HISTORIC AND DESIGN REVIEW COMMISSION

June 19, 2019

HDRC CASE NO: 2019-321
ADDRESS: 523 CEDAR ST
LEGAL DESCRIPTION: NCB 2878 BLK 3 LOT 11
ZONING: RM-4, H
CITY COUNCIL DIST.: 1
DISTRICT: King William Historic District
APPLICANT: TREVINO EDUARDO R &
OWNER: TREVINO EDUARDO R &
TYPE OF WORK: Porch Replacement
APPLICATION RECEIVED: May 31, 2019
60-DAY REVIEW: August 18, 2019
CASE MANAGER: Huy Pham

The applicant is requesting a Certificate of Appropriateness for approval to replace the existing, tongue and groove front porch decking with new 1x6 decking.

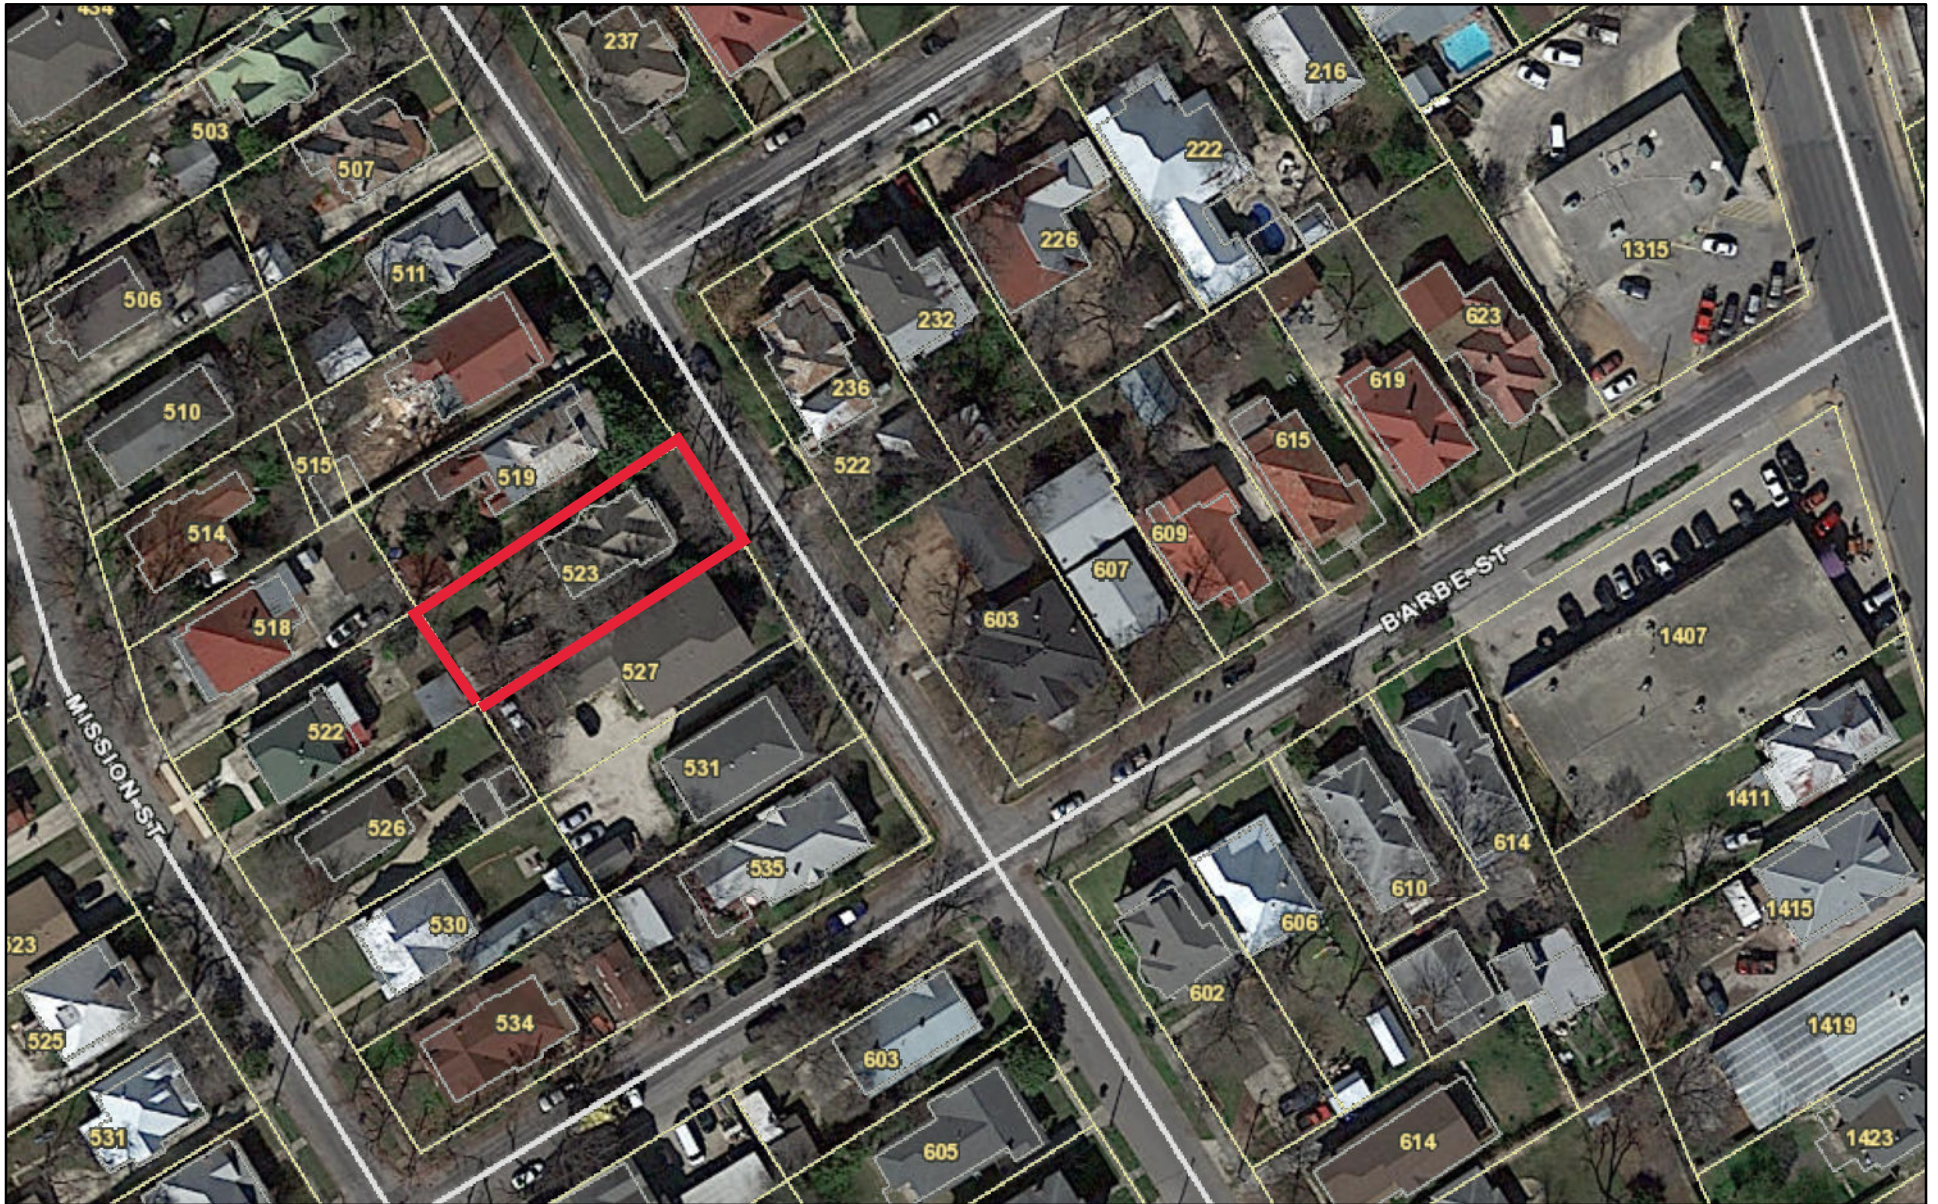
- b. **COMPLIANCE** – On a site visit conducted on May 30, 2019, staff found that the front porch tongue-and-groove decking was replaced with 1x6 boards including the removal of some column capitals. The applicant submitted an application May 31, 2019, to be heard at the next available HDRC hearing.

- c. **PORCH DECK** – The applicant has proposed to install 1x6 wood boards to replace traditional wood tongue-and-groove decking; the orientation of the boards remains perpendicular to the front façade plane of the home. Per the Guidelines for Exterior Maintenance and Alterations 2.7.B.iii., porch elements should be replaced in-kind when deteriorated beyond repair and when in-kind replacement is not feasible, the design should be compatible in scale, massing, and detail while materials should match in color, texture, dimensions, and finish. Staff finds that the 1x6 boards are inconsistent with the Guidelines and replacement decking should feature wood tongue-and-groove decking with approximately 1 inch in height and 3 inches in width laid perpendicular to the front façade plane of the historic structure.

Staff does not recommend approval based on finding b and c. In-kind replacement of 1x3 tongue-and-groove decking should be installed instead and the column capitals should be restored.
